**Proposed amendments to ECE/TRANS/WP.29/GRRF/2008/2  
as agreed at the 63rd GRRF session**

**A. PROPOSAL**

Insert a new Annex 10, to read (including its Appendices 1 and 2):

SPECIAL REQUIREMENTS TO BE APPLIED TO BRAKE ASSIST SYSTEMS,  
WHERE FITTED

Figure 1a: Pedal force characteristic needed in order to achieve maximum deceleration with category 'A' BAS

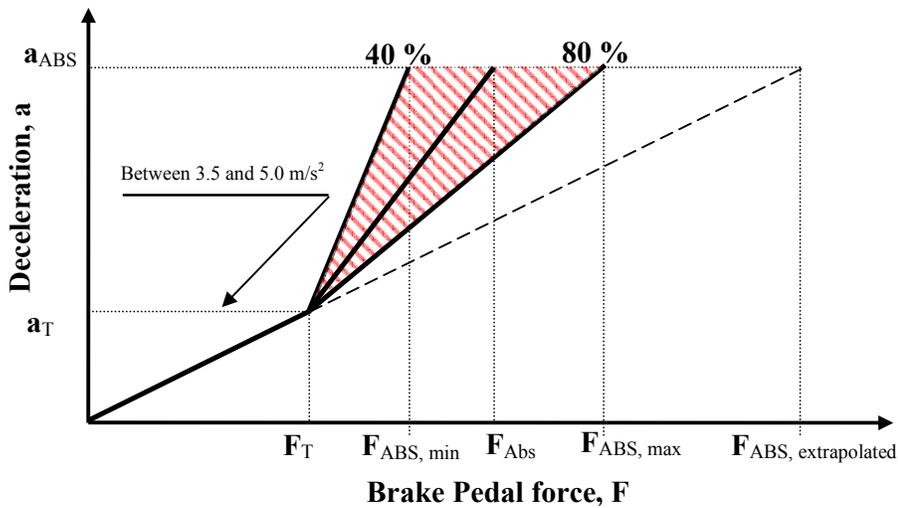
3.2.4. A straight line is drawn from the origin through the point  $F_T, a_T$  (as shown in Figure 1a). The value of brake pedal force 'F', at the point of intersection between this line and a horizontal line defined by  $a=a_{ABS}$ , is defined as  $F_{ABS, extrapolated}$ :

Figure 1b: Pedal force characteristic needed in order to achieve maximum deceleration with category 'A' BAS

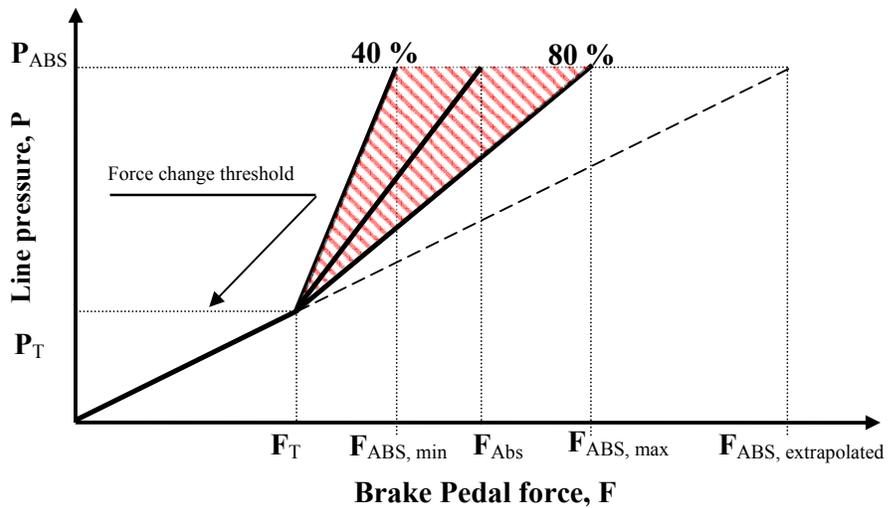
3.2.5.3. **Figure 1b shall be constructed in the manner set out in paragraph 3.2.4., but using line pressure measurements to define the parameters set out in paragraph 3.2.5. above where:**

$$F_{ABS, extrapolated} = \frac{F_T \times P_{ABS}}{P_T}$$

Figure 2: **Example of test 2** of a category 'B' BAS system

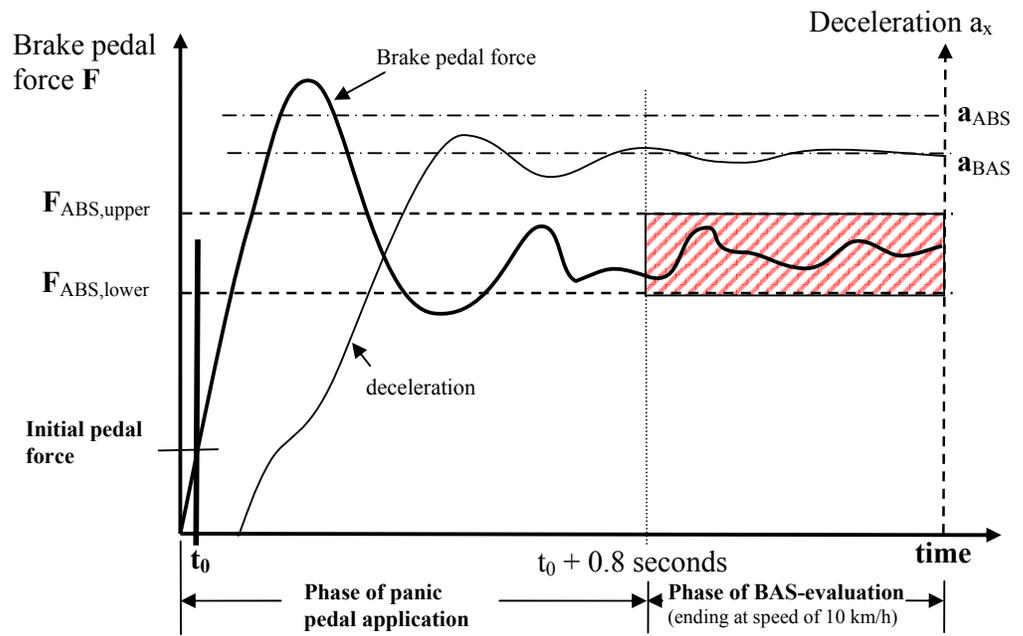
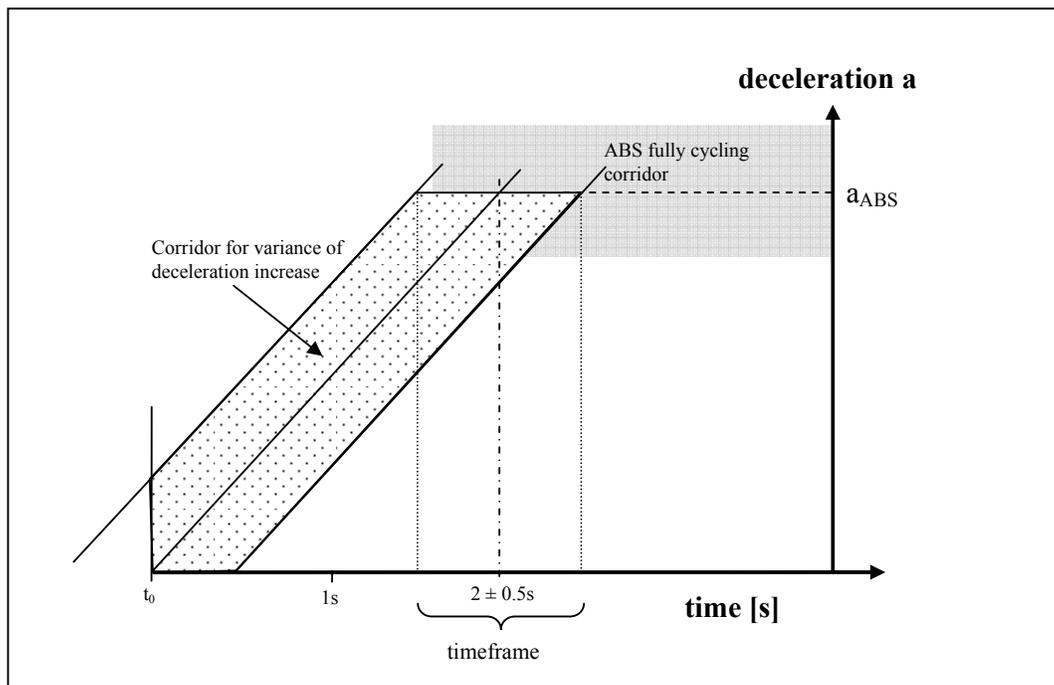
The vehicle shall be driven in a straight line at the test speed specified in paragraph 2.4. above. The driver shall apply the brake pedal quickly according to Figure 2, simulating emergency braking so that BAS is activated and ABS is fully cycling.

After  $t = t_0 + 0.8$  s and until the vehicle has slowed down to a speed of 10 km/h the brake pedal force shall be maintained in a corridor between  $F_{ABS, upper}$  and  $F_{ABS, lower}$ . Where  $F_{ABS, upper}$  is  $0.7 F_{ABS}$  and  $F_{ABS, lower}$  is  $0.5 F_{ABS}$ .

Figure 4: Determination of the value of  $F_{ABS}$

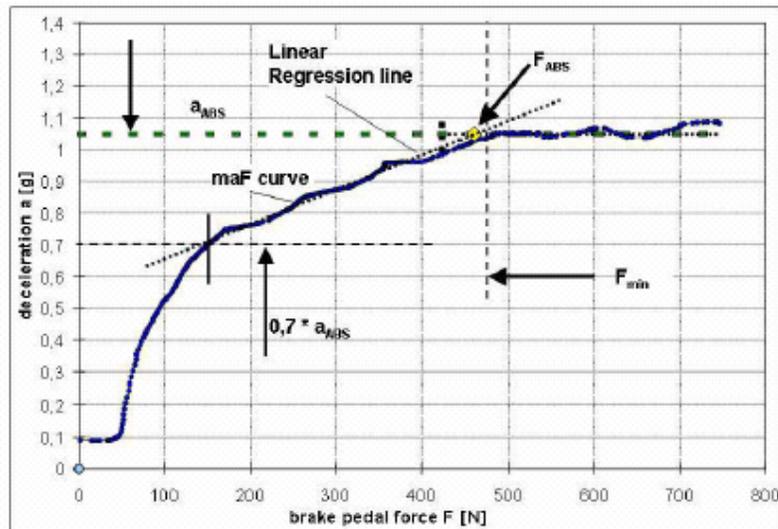
- 1.8. The five individual 'deceleration versus brake pedal force' curves are averaged by calculating the mean deceleration of the five individual 'deceleration vs. brake pedal force' curves at increments of 1 N pedal force. The result is the mean deceleration versus brake pedal force curve (Figure 4), which will be referred to as the "maF curve" in this appendix.

- 1.10. Using linear regression, a straight line is drawn through all maF curve values below the pedal force  $F_{min}$  and above the line representing 70 per cent of ABS deceleration ( $0.7 * a_{ABS}$ ). The value of the brake pedal force ' $F$ ' at the point of intersection between this line and the horizontal line where  $a = a_{ABS}$  is defined as  $F_{ABS}$ .
